File No: SP 23-04 Center Market

Summary: On February 6, 2024, the Millersburg Planning Commission held a public hearing for the project. The Commission approved the Site Development Review with the conditions of approval listed in the staff report, as revised by the Commission, with a 6-1 vote. Commissioner Thomas voting no on the approval motion. The Commission found that all criteria and standards were met based on the accepted facts and the conditions of approval as modified. The Commission relied on facts from the staff report, the applicant's materials, and the City's Comprehensive Plan, Codes, and Ordinances as provisions for the basis of their decision. The Commission elected to revise two conditions of approval, 22 and 12. Condition of approval 22 addressed mitigation for the removal of mature trees from the project site. Condition of approval 12 addressed access between the site and the neighboring site. After the hearing, in order implement the direction provided by the planning commission, staff further identified that condition of approval 14 was redundant with the modifications to condition of approval 22 and should be deleted. Condition of approval 14 addressed the c

LAND USE
 16 NOVEMBER 2023
 SCALE/NTS
 CIVIL SITE
 PLAN

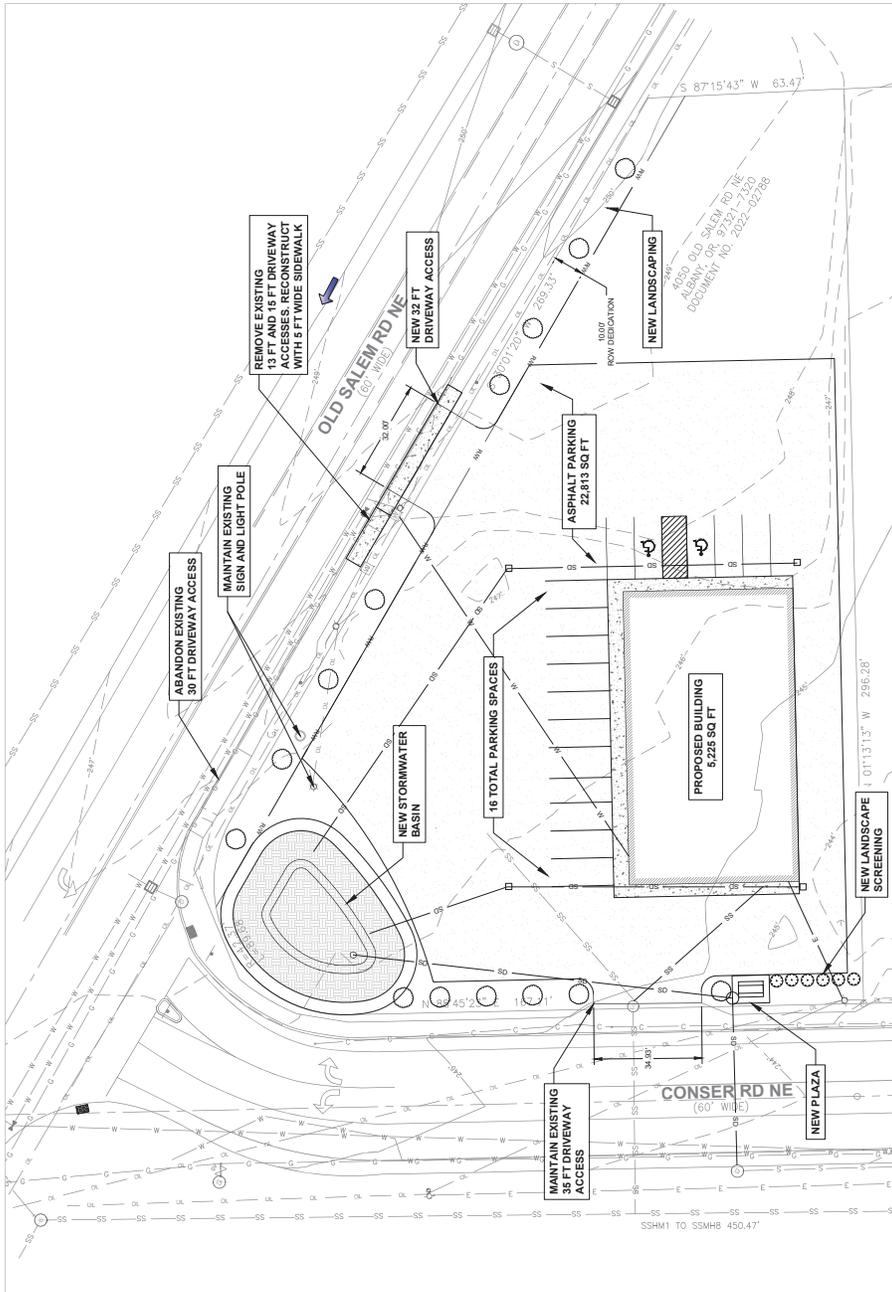
- Prior to final inspection the Applicant shall provide a revised landscape plan for review and approval. The plans shall include:
 - a. All trees shown on the preliminary landscape plan, with the exception of any that need to be removed due to any vision clearance conflicts,

- b. Curbed, 5 feet wide landscape planter bays shall be included at the ends of each series of parking spaces.
 - c. At least two trees shall be included in each of the four landscape planter bays in the parking area.

- Prior to the issuance of building permits, the applicant shall provide a revised site plan showing:
 - Internal pedestrian connection locations with the neighboring lots. These need not be constructed at this time, but must be shown on the plans.
 - Curbed, 5 feet wide landscape planter bays shall be included at the ends of each series of parking spaces.
 - Clear vision areas shall be shown in compliance with Section 3.08.060 of the Development Code.

Figure 1- Root Protection Zones

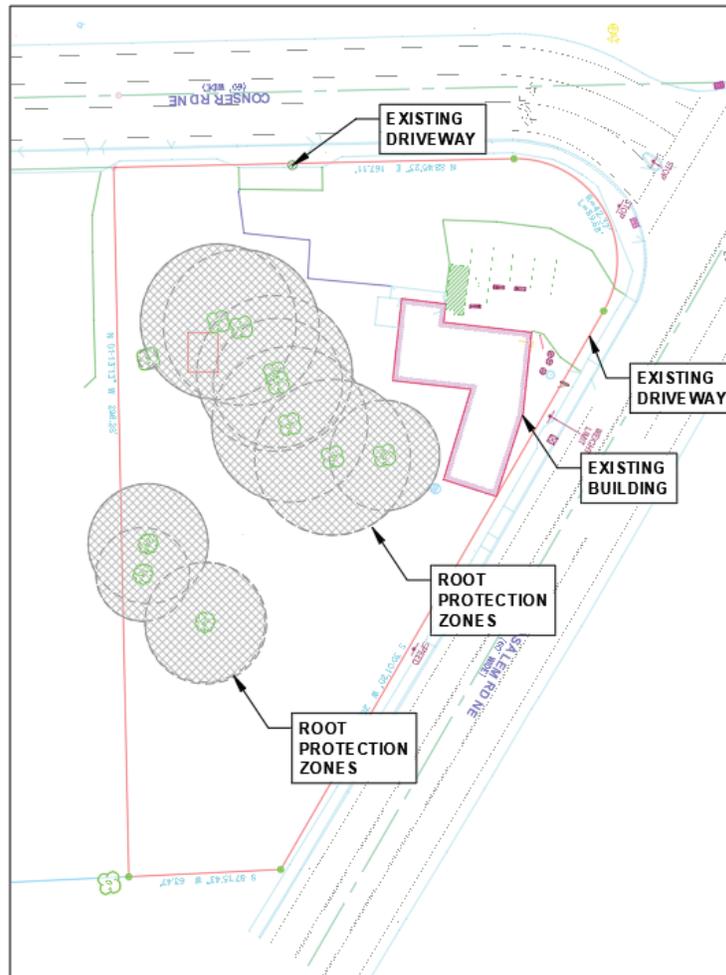
In the staff report, Staff determined that the removal of the trees had a negative impact. While the Municipal Code may not require a tree removal permit, the intent of the Code is clear – trees of this size are something that should be considered significant. Having that said, it is necessary to consider the applicant's rights to develop his private property and the tree's locations do significantly impact the ability to use the site (see the applicant's narrative regarding trees and their root zones).

The Planning Commission discussed the tree issue extensively, ultimately deciding that the 2:1 mitigation was likely too difficult to achieve given the design of the site, and instead, the trees proposed on the tentative landscape plan, plus the required addition of 4 parking lot landscape planters with two trees in each, would suffice for mitigation. They also required that all trees planted on the site be at least 3 inches in diameter. This also made condition of approval 14, proposed in the staff report, redundant. That condition was deleted. Originally 22 spoke to just the mitigation trees. The Commission expanded the text of 22 to address several changes that needed to be reflected on the revised landscape plans. However, condition 14 also included details of what needed to be reflected on revised landscape plans. The Commission's action essentially merged these two conditions into one. The revised condition is shown below.

SHEET #
 A3.0

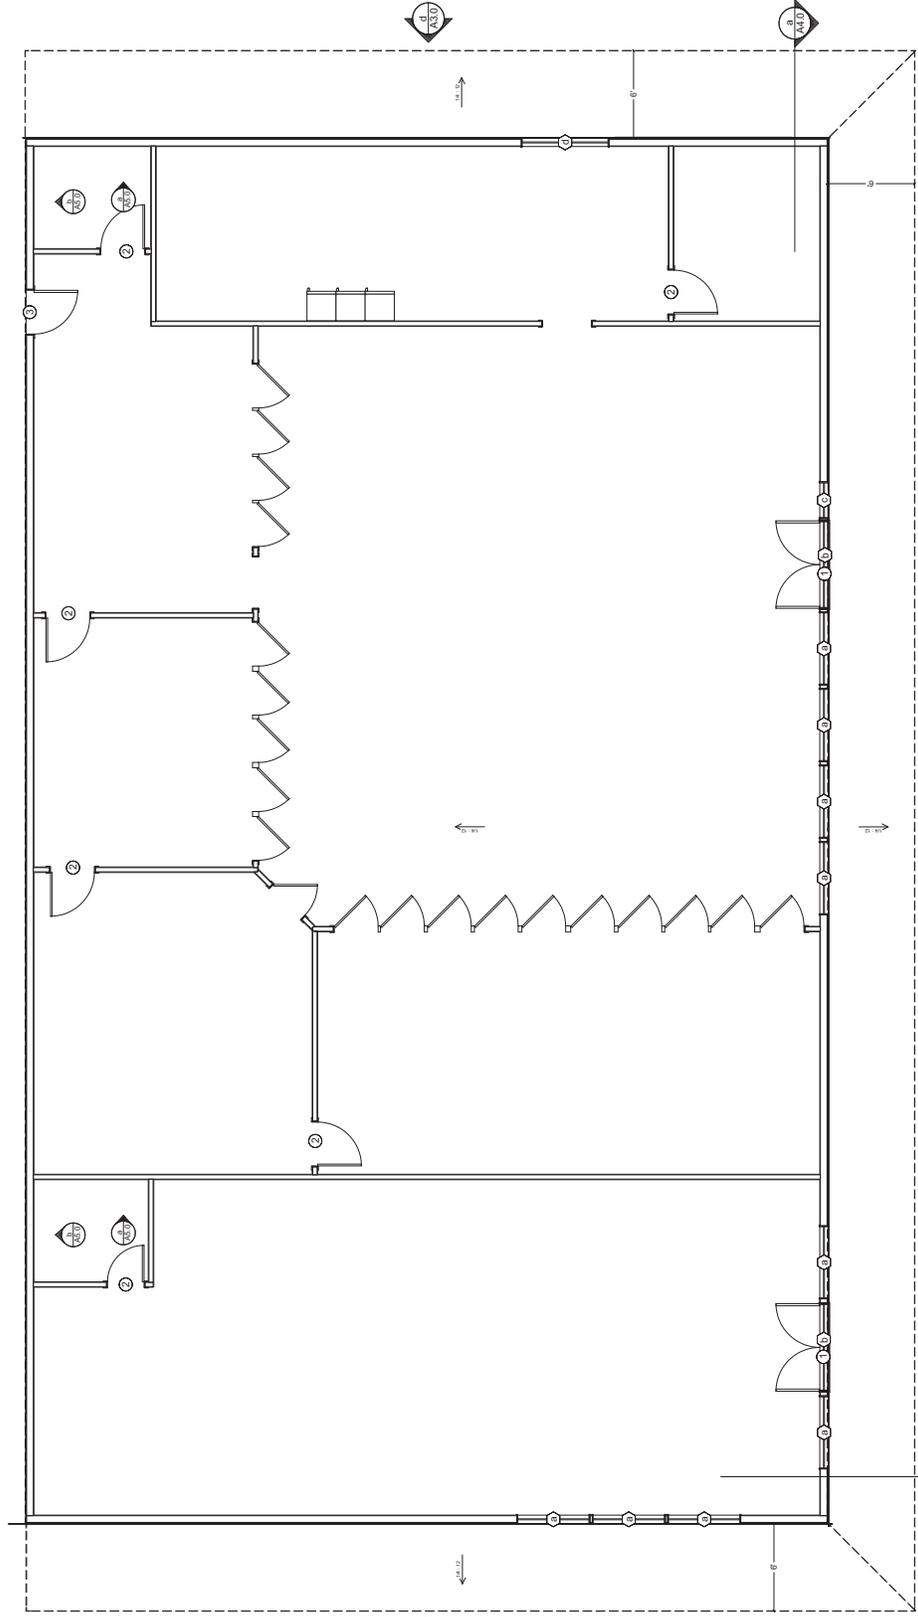
application of this requirement is not practical because windows on the rear of the structure of a convenience store are not typically included. However, the intent of the provision is clear, the rear of the structure should include some kind of aesthetic feature. A condition of approval has been added that will require the addition of architectural features intended to break up the massing of the structure and make the structure aesthetically pleasing from NE Conser Road. Because this is subjective, the Planning Commission can add any details to the condition in order to assure (to the Commission) that the requirement will be satisfied. The condition requires the applicant to work with Staff to satisfy the condition, this way the project does not have to come back to the Planning Commission. Staff found this to be a reasonable interpretation of this development standard, though, ultimately, it is up to the Planning Commission.

- Clear vision areas shall be shown in compliance with Section 3.08.060 of the Development Code.
13. Prior to issuance of building permits the applicant shall revise the rear elevation (west facing) to break up the massing of the façade and include at least one (1) architectural feature intended to make the view of the rear wall from NE Conser Road aesthetically pleasing. This can include stone wainscoting, awnings, bump outs in the wall plane (at least 6 inches), to add shadows along the facade throughout the day, landscaping, or any other feature that accomplishes the goals outlined above. These shall meet the satisfaction of the Community Development Director.
